FOUNDATION INVESTIGATION REPORT
For

Proposed Crossing at Murky Creek
And Hwy. #58^{1/2}

District No. 19 (Thunder Bay)
H.O. 70-11058 -- W.P. 29-68-02

Murky Creek Bridge,
30.2 Mi. North of Jct. Hwy. #11
W.P. #29-68-02 Site No. 48E-4
Hwy. #584 District #19.

FIGURE 5

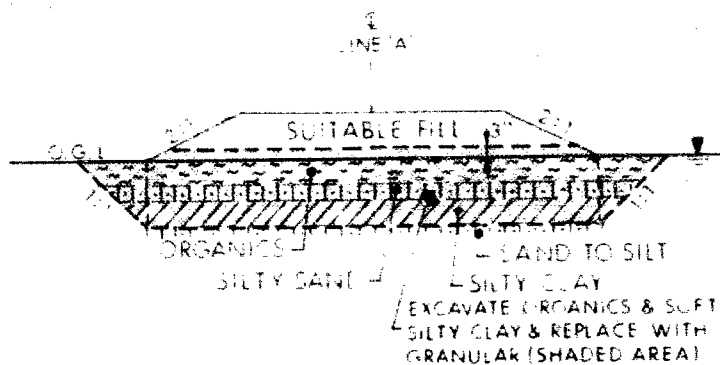
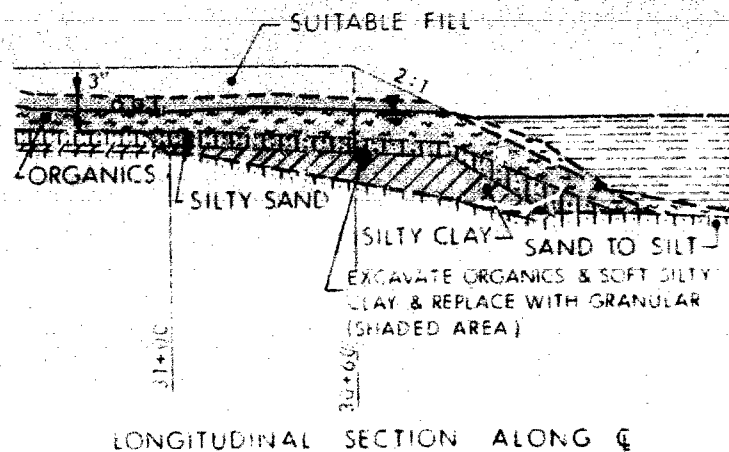
It is presumed that the extent of excavation
at north and south approaches (as shown on grading
drawings, not attached) conforms to the recommendations
contained in our report, specifically Figs 5 and 6.
There is no table of pile lengths included. No other
comments
